FIELD ENGINEERING BULLETINTITLE: CHANGING OPERATING-SPEED PAIR AND
MASTER BIAS OPERATION**I. APPLICABILITY**

All ATR-100's.

To change operating-speed pair and master bias operation for the ATR-100 Recorder/Reproducer.

Figure 1. Overlay panels, Audio Control PWA No. 5.

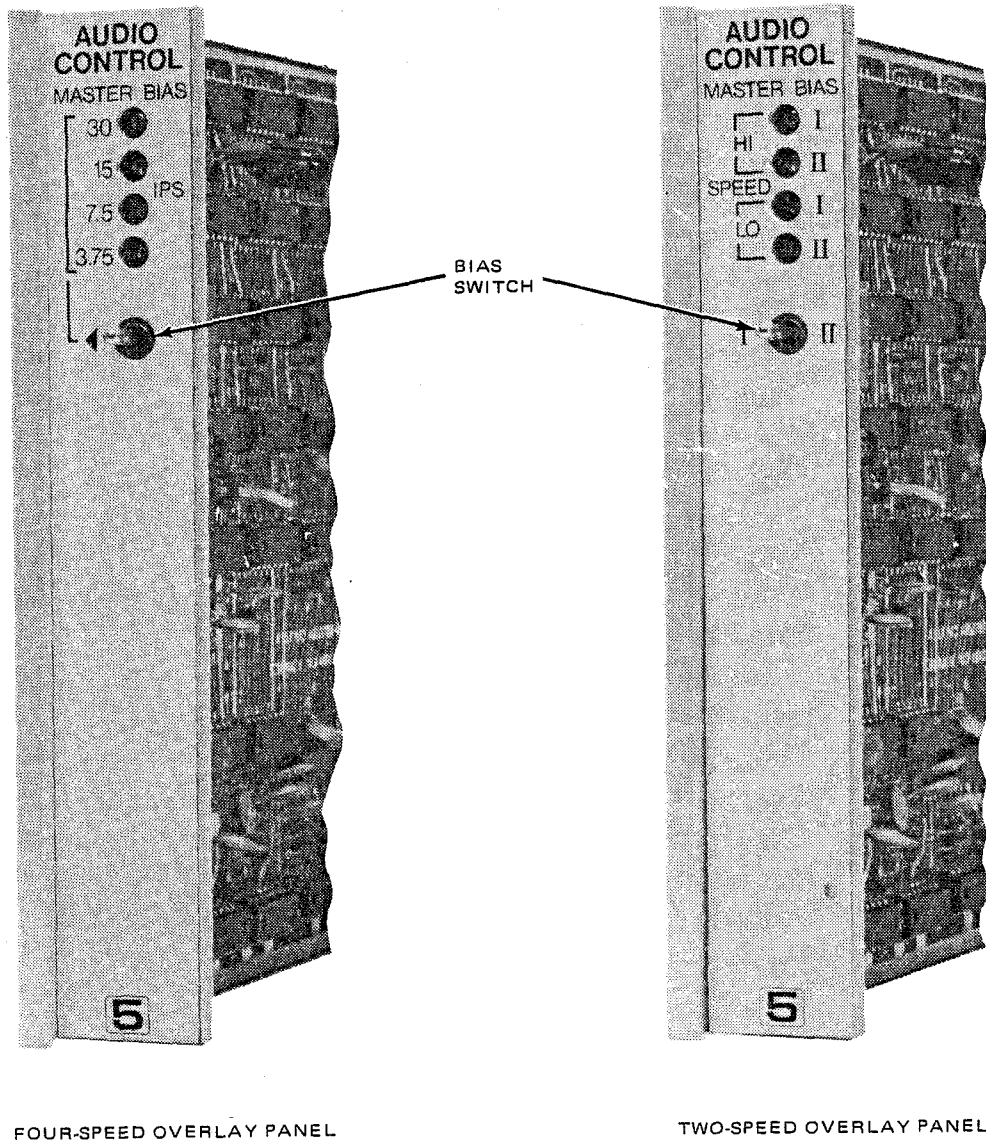
2. If two-speed overlay panel (Figure 1) is not in the front position on the PWA, remove front-panel screw, interchange overlay panels, and reinstall screw.
3. Position HI speed jumper J1 to the desired high speed 30, 15, or 7.5-in/s position (Figure 3).
4. Position LO speed jumper J2 to the desired low speed 15, 7.5, or 3.75-in/s position.
5. Position jumpers J3 and J4 to the S (stored) position. Reinstall audio control PWA no. 5.
6. For each new speed selected, perform the appropriate signal system alignment procedure indicated in this FEB.

1. With power off, remove audio control PWA no. 5 from the electronics assembly.
2. If four-speed overlay panel (Figure 1) is not in the front position on the PWA, remove front-panel screw, interchange overlay panels, and reinstall screw.
3. Position jumper J1 to the 30-in/s position (Figure 3).
4. Position jumper J2 to the 7.5-in/s position.
5. Position jumper J3 to the 15-in/s position.
6. Position jumper J4 to the 3.75-in/s position. Reinstall audio control PWA no. 5.
7. For each new speed selected, perform the appropriate signal system alignment procedure indicated in this FEB.

Figure 2. Speed Selection Jumpers, Padnet PWA.

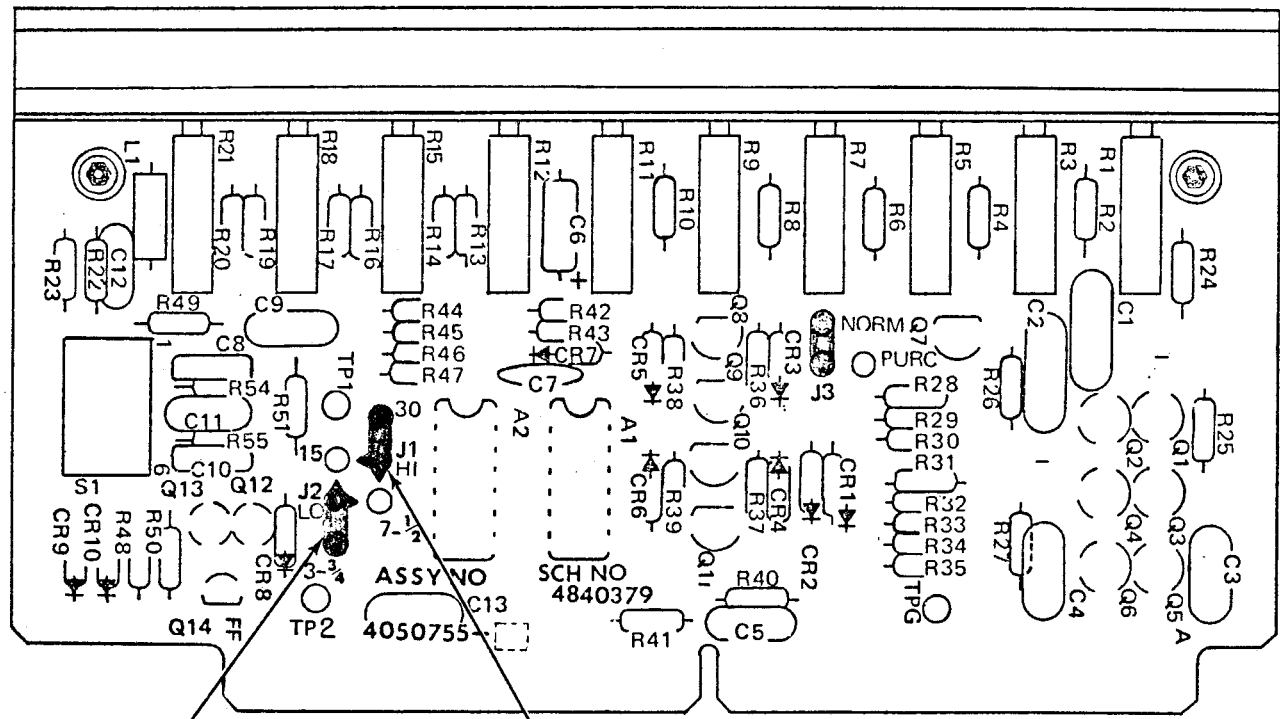
1. With power off, remove the PADNET PWA for each channel from the electronics assembly.
2. Position HI speed jumper J1 to the desired high speed 30, 15, or 7.5-in/s position (Figure 2).
3. Position LO speed jumper J2 to the desired low speed 15, 7.5, or 3.75-in/s position. Reinstall PADNET PWA (s).

FIG I

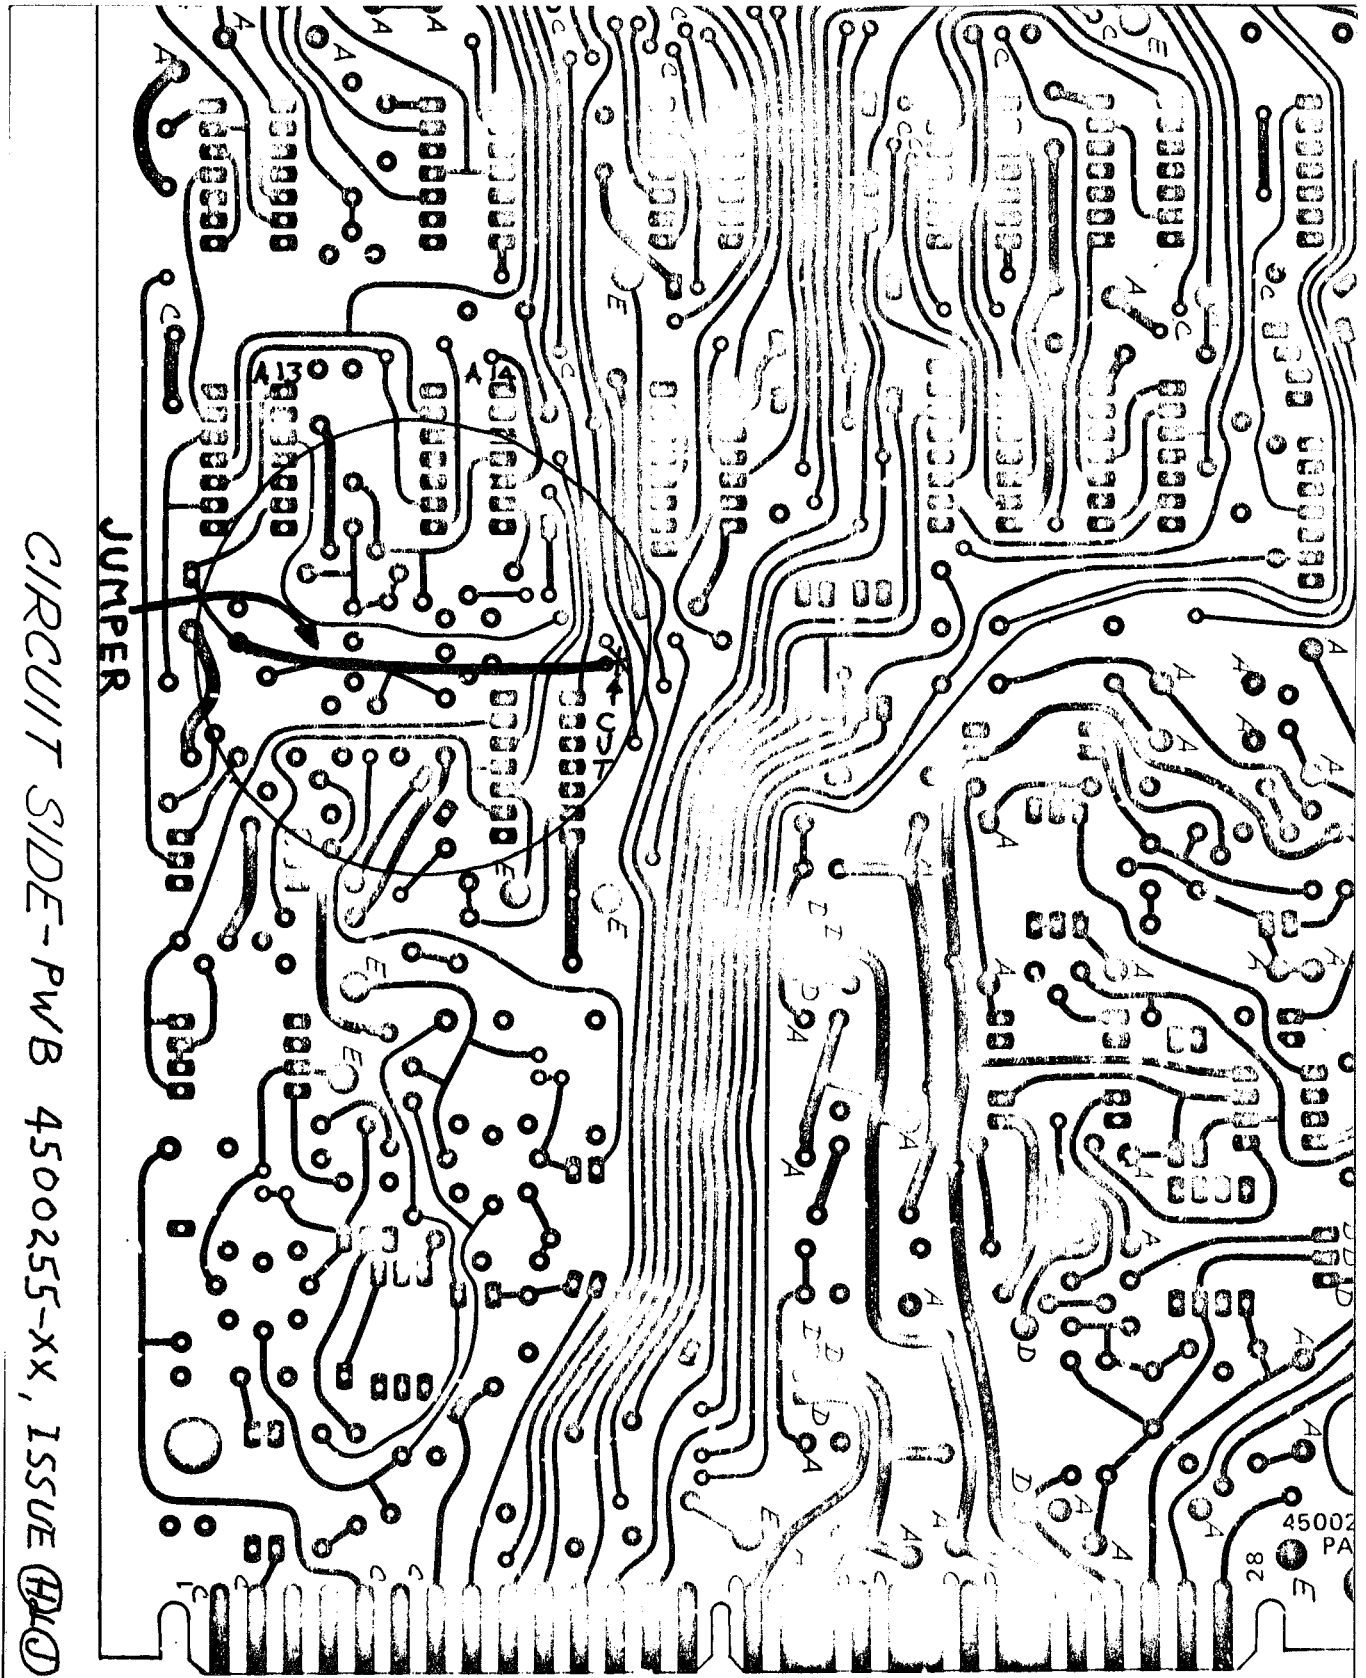
V. PROCEDURE**A) PWB 4500255-XX (Fig. I)**

Remove the PWA from the shield. On the circuit side of the board, along side Pin 28, is the P/N 4500255-XX. Just below this is the issue letter of the board. Issue letters H and J only should be modified.

Locate the short trace connecting R94 to A14-3. (See fig. I). Cut trace per dwg. and install short insulated jumper from R94 to A13-6. Re-install PWA onto shield and check for proper operation of the capstan servo. No re-adjustment of the servo system is necessary.

FIG II

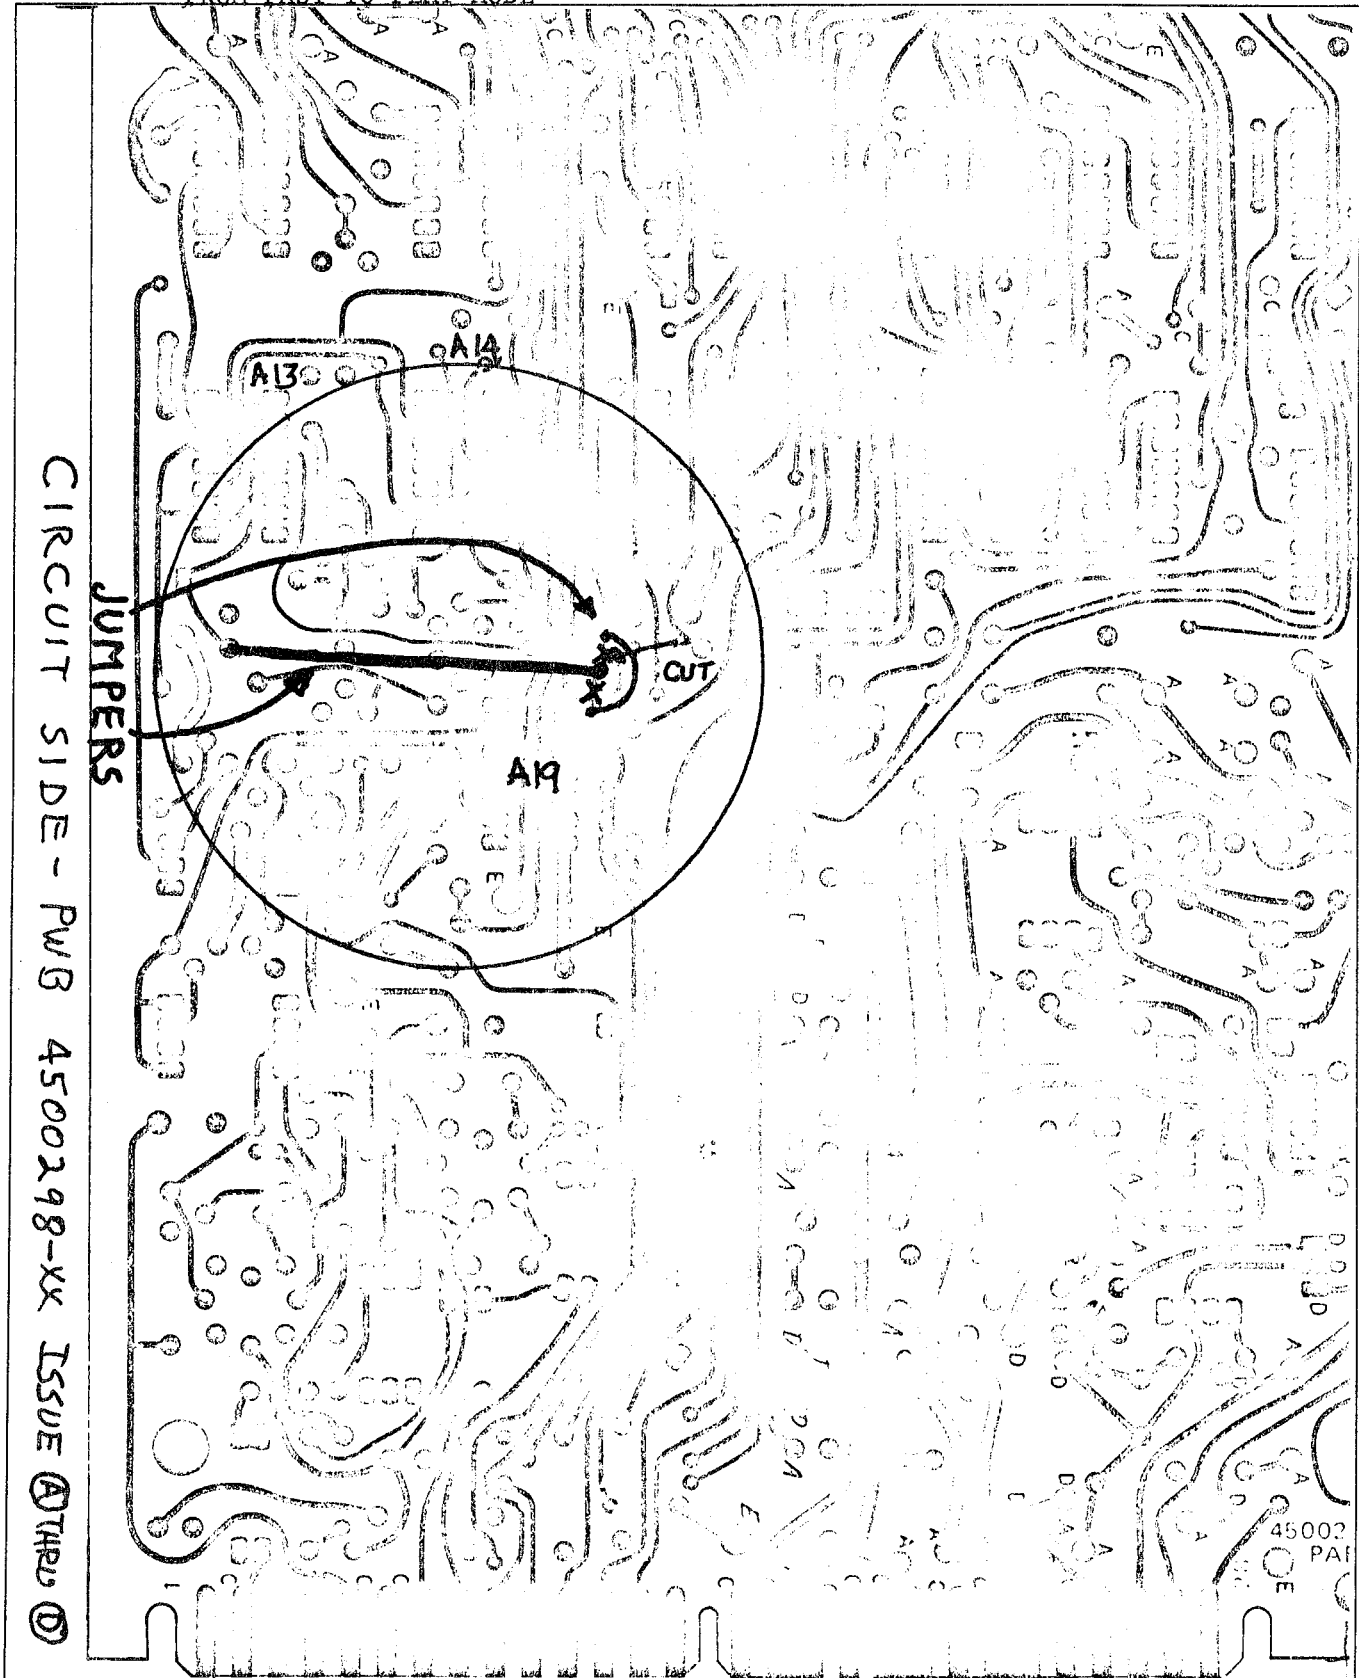
B) PWB 4500298-XX (Fig. II)

Remove the PWA from the shield. On the circuit side of the board along side Pin 28, is the P/N 4500298-XX. Just below this is the issue letter of the board. Issue letters A thru D need to be modified. Issue letters E and later have had the circuitry changed, and do not require this modification.

Locate the trace connecting R94 to A14-3 (see fig. II)
Cut trace in two places per drawing and install a short
insulated jumper bridging the pad that R94 is soldered
to. With a longer insulated jumper connect from the R94
pad to A13-6 per drawing. Re-install PWA onto shield
and check for proper operation of the capstan servo.
No re-adjustment of the servo system is necessary.
